**FINAL DIVISION OF SAFETY SYSTEMS INTERIM STAFF GUIDANCE  
DSS-ISG-2010-01  
Revision 0**

**STAFF GUIDANCE REGARDING THE NUCLEAR CRITICALITY SAFETY ANALYSIS FOR  
SPENT FUEL POOLS**

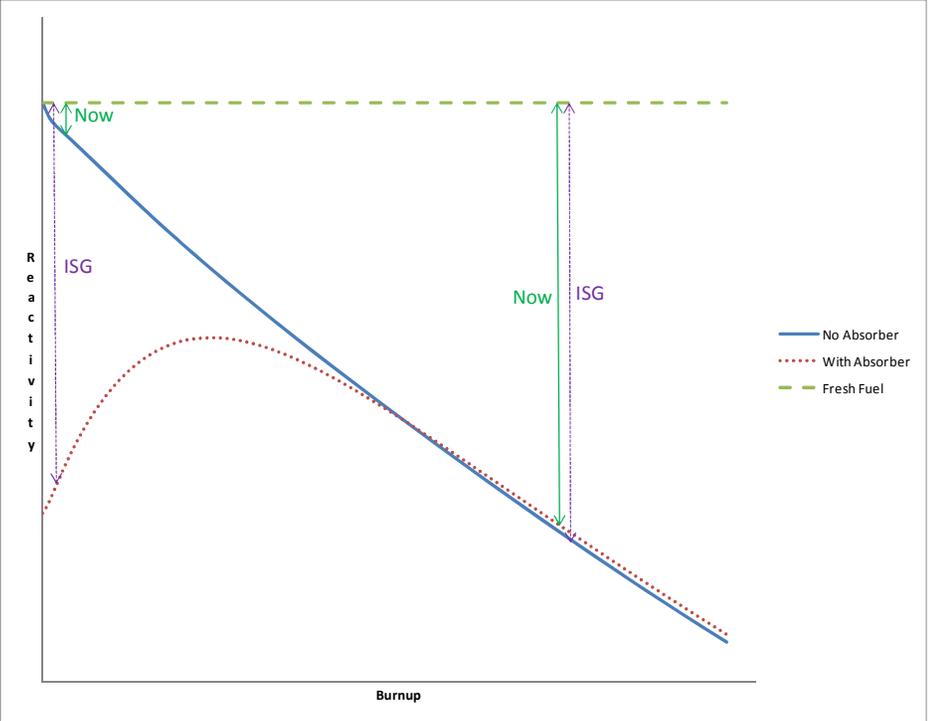
NO.	ISG Section	COMMENT	NRC Response
		<p>2. The wording “with or without residual neutron absorber” in this section creates an inconsistent application of conservatisms in two cases as described below. Please consider revising this section.</p> <p>Case 1: The first inconsistency impacts the application of the depletion uncertainty at low burnups with burnable neutron absorbers (IFBA, Gd, erbia, WABA, BPRA, Pyrex, etc). As shown on the left side in Figure 1 (provided at the end of this attachment), the difference in reactivity between an assembly that contains burnable absorbers versus an assembly that does not contain burnable absorbers is significant at low burnups. Applying 5% of the reactivity difference between the fresh assembly and the assembly with burnable absorbers would suggest that a significant conservative uncertainty be applied even in the case where the residual neutron absorber is not credited in the low burnup assembly. This would also create a large discontinuity in the maximum <math>k_{eff}</math> (which includes all biases and uncertainties) between the fresh fuel assembly where integral absorber is not credited in the spent fuel pool and the slightly burned fuel assembly, where the large “depletion uncertainty” would be applied according to the prescription in the draft ISG. Neglecting the residual burnable absorber is a much more significant conservatism than applying the 5% depletion uncertainty and therefore it is not necessary to apply both of these conservatisms.</p> <p>Case 2: The guidance as written would recommend a double application of conservatisms from two separate configurations. To illustrate this point, Figure 1 shows the reactivity of two fuel assemblies in a representative spent fuel storage rack as a function of burnup. The first</p>	<p>be essentially no change in reactivity, thereby rendering the reactivity change ineffective in estimating the depletion uncertainty.</p> <p>2. In Case 1 the commenter presents a scenario with the fuel assembly having a large initial BA loading. The commenter’s figure appears to show that for fuel assemblies with large initial BA loadings the DSS-ISG guidance on determining the depletion uncertainty will be unnecessarily conservative at lower burnups. The NRC staff agrees that there will be cases at low burnups where following the ISG guidance could be unnecessarily conservative. However, as pointed out in NEI comment 7.1 burnups in this range are rarely credited. The NRC staff does not believe it is productive to provide guidance for something that may not occur during the life of the DSS-ISG. Additionally, the NRC staff believes that more moderate BA loadings will result in less dramatic conservatisms, and the NRC staff guidance should consider those scenarios as well.</p>

NO.	ISG Section	COMMENT	NRC Response
		<p>assembly (dotted line) includes burnable absorbers, while the second assembly (solid line) is identical to the first, only without the burnable absorber. The reactivity of the fresh fuel assembly is also shown as the horizontal (dashed) line. If the draft guidance were followed verbatim, the depletion uncertainty would have to be calculated based on the difference in reactivity of the fresh fuel assembly and the assembly that contained no neutron absorber, because it has the lower reactivity at higher burnups as shown in the left of Figure 1. However, as suggested by ISG Section IV.2.c, burnable absorbers must be considered in their effect of hardening the spectrum and providing a more reactive fuel assembly at the same burnup and enrichment. As a result, the NRC has specified in the draft ISG the application of conservatisms from two different physical configurations.</p> <p>3. The definition of reactivity decrement suggested here is arbitrary and inconsistent with physical reality as discussed above. To be consistent, the guidance should read that the reactivity decrement should be the largest of the following three scenarios (noting that all might not be applicable to a specific criticality analysis application): (1) the difference in the <math>k_{eff}</math> of a fresh unburned assembly with no burnable poison to the <math>k_{eff}</math> of the same assembly with the credited amount of burnup; (2) the difference in the <math>k_{eff}</math> of a fresh unburned assembly with no burnable poison to the <math>k_{eff}</math> of the same assembly with the credited amount of burnup, depleted with a fixed burnable absorber to the maximum burnup permitted with the fixed burnable absorber present, but with the fixed burnable absorber removed at the credited burnup; or (3) the difference in the <math>k_{eff}</math> of a fresh unburned assembly with an integral poison present to the <math>k_{eff}</math> of the same assembly with the credited amount of burnup,</p>	<p>In Case 2 the comment indicates that there is a double application of conservatisms. Consideration of the burnable absorber effect on the final reactivity of a depleted fuel assembly is not a conservatism. The delta shown in the figure is small. 5% of the delta would likely have a negligible impact on the total final estimated keff and therefore does not warrant separate guidance.</p> <p>Therefore, no change was made to the guidance and as with any guidance, applicants can use alternate methods, provided those methods are technically sound.</p> <p>3. The DSS-ISG guidance does contain a bit of artificiality. However, the guidance continues the Kopp Letter guidance of using a reactivity decrement to estimate the depletion uncertainty. The DSS-ISG guidance on how to determine the reactivity decrement includes scenarios the Kopp Letter does not, as noted in the NRC staff response to NEI comment 7.1. The DSS-ISG guidance is simple and should be conservative over all scenarios. The commenter's suggestions would not be</p>

NO.	ISG Section	COMMENT	NRC Response
		<p>depleted to that credited amount of burnup with the integral absorber present, and with the residual integral burnable absorber present.</p> <p>4. This section narrowly discusses single assemblies, while sometimes cell combinations are analyzed. For example, if a 2x2 array in the pool is analyzed and qualified to have 3 spent fuel assemblies and one empty cell, then the reactivity change associated with a single assembly (i.e. infinite array of assemblies) would be overly conservative as the basis for the depletion uncertainty, and the reactivity change associated with changing the three assemblies in the array to three fresh assemblies would be more appropriate. The text should be changed to consider such conditions.</p>	<p>conservative over all scenarios. As with any guidance, applicants can use alternate methods, provided those methods are technically sound. Therefore these recommendations were not incorporated into the DSS-ISG.</p> <p>4. The comment notes that as storage configurations change the burnup of interest can change. DSS-ISG-2010-01 states the reactivity change will be based on the "...burnup of interest..." Therefore, these scenarios are already covered and no change to DSS-ISG-2010-01 has been incorporated.</p>
